May 8, 2013

RE: THE DIAMOND LODGE  
PERMIT NO. 3PR00505\*AD  
PORTAGE COUNTY  
EDINBURG TOWNSHIP

Figure 5

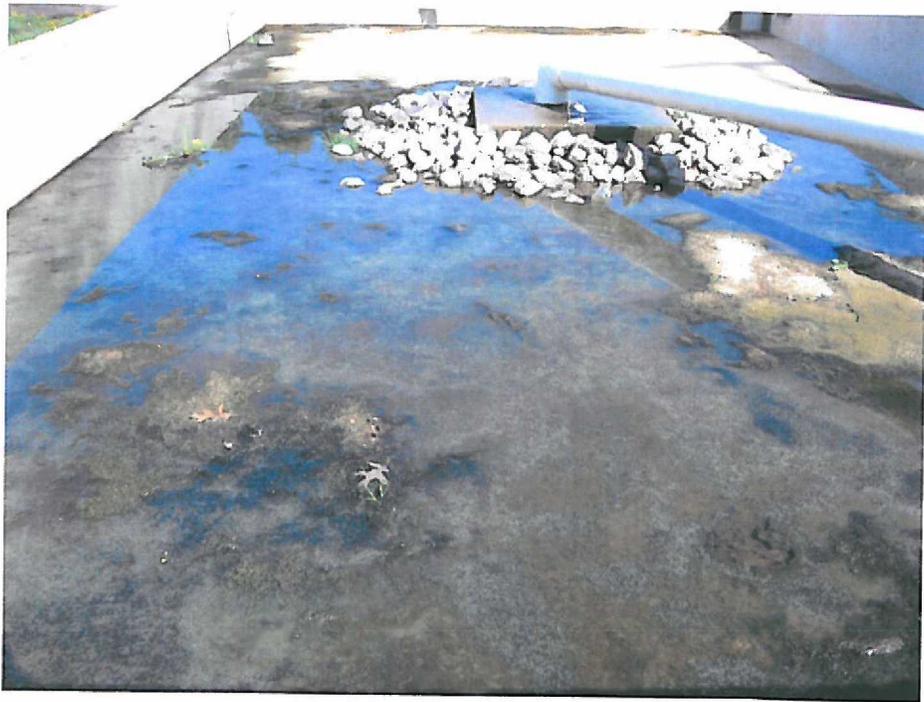
19. Currently, the west cell is being used. The west cell splash pad needs to be leveled. The effluent is not being evenly distributed across the cell. The effluent is flowing to the south side of the cell and ponding. This is the result of a layer of sludge that is present on the surface of the filter media. See Figure 5 & 6. The condition of surface sand filter cells should be addressed immediately.
